Project	IEEE 802.16 Broadband Wireless Access Working Group < http://ieee802.org/16 >	
Title	802.16g Figure 1 issues	
Date Submitted	2005-03-14	
Source(s)	David Johnston Intel Corporation	Voice: (503) 264 3855 Email: dj.johnston@intel.com
Re:	Call for comments	
Abstract		
Purpose	This document attempts to clarify what delta changes 802.16g should make to 802.16-2004 (as amended by succeeding amendments)	
Notice	This document has been prepared to assist IEEE 802.16. It is offered as a basis for discussion and is not binding on the contributing individual(s) or organization(s). The material in this document is subject to change in form and content after further study. The contributor(s) reserve(s) the right to add, amend or withdraw material contained herein.	
Release	The contributor grants a free, irrevocable license to the IEEE to incorporate material contained in this contribution, and any modifications thereof, in the creation of an IEEE Standards publication; to copyright in the IEEE's name any IEEE Standards publication even though it may include portions of this contribution; and at the IEEE's sole discretion to permit others to reproduce in whole or in part the resulting IEEE

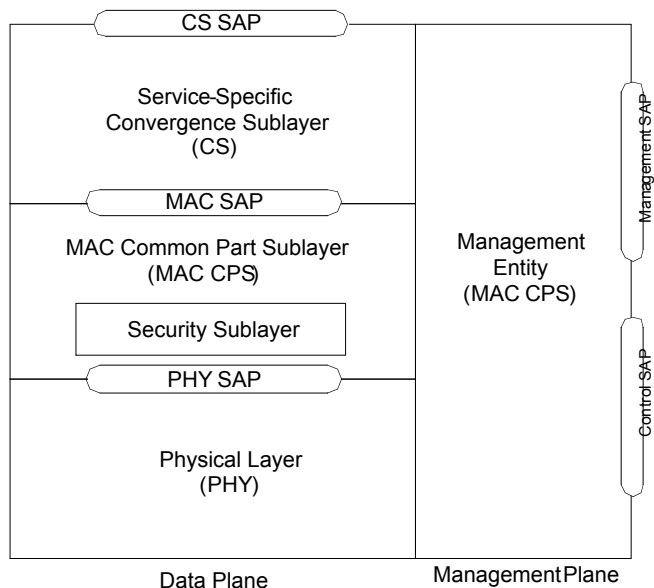
- This diagram does not describe the diagram that 802.16g would insert into 802.16-200x. Taking 802.16-2004 as an example, the diagram describes data and management planes, data plane interfaces and outlines the scope of 802.16-2004 as being limited to the data plane.
- The diagram above separates out control and management planes. This may be an appropriate separation of function in 802.16g, however this separation of function is not expressed in the base document. As such, the control/management split may be considered a hierarchical split underneath the management plane as expressed in the base document.

- The scope of 802.16g in the above diagram is limited by the PAR to management procedures and logically this would correspond to the dotted rectangle on the right hand side of the above diagram.
- 802.16g will create an amendment that leads to a specification with a scope encapsulating both data and management planes.
- The internal separation of MAC, PHY and CS does not map to the data plane separation and implies that separate control and management SAPs for each layer are required.

Accordingly, the stack diagram in Doc 05-010r1 is appropriate for either informative material describing the scope and internal structuring of 802.16g, however the actual diagram in 802.16 that is proposed as a replacement for figure 1 in the base 802.16 would map this structure into the base document's diagram.

Replace figure 1 with:

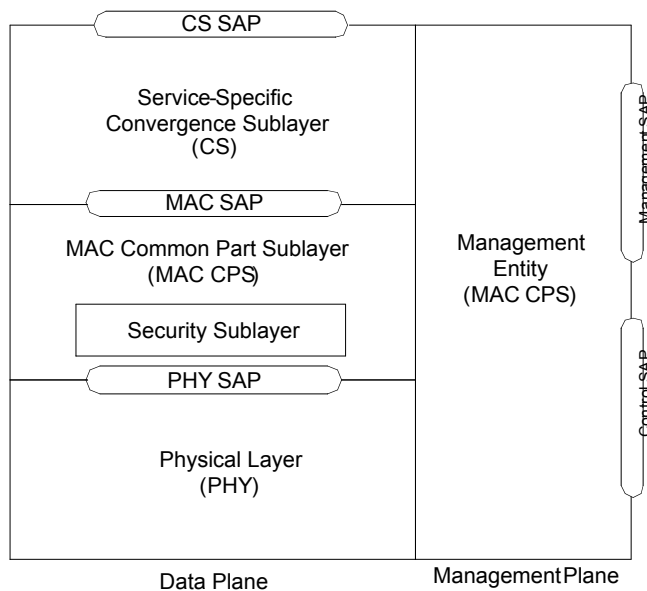
This diagram maps both interfaces into the management plane in the base standard, while they may still hook into the separate control and management entities expressed in 802.16g.

The dotted line scope delimiter is removed, since the scope of the amended specification will encapsulate the whole of the stack, even though the scope of 802.16g is limited to the management side.

The dotted line separation of security management appears superfluous, given that the security management protocols obviously appear in the management plane along with all the other management protocols. With the network model and SAPs proposed, we might expect primitives related to security to appear on one of

the management SAPs and map to the interface to the ASA in the proposed network model. Accordingly in the proposed diagram there is no separation of the security management entity.

[Replace figure 1 with the following diagram]

Replace figure 1 with:
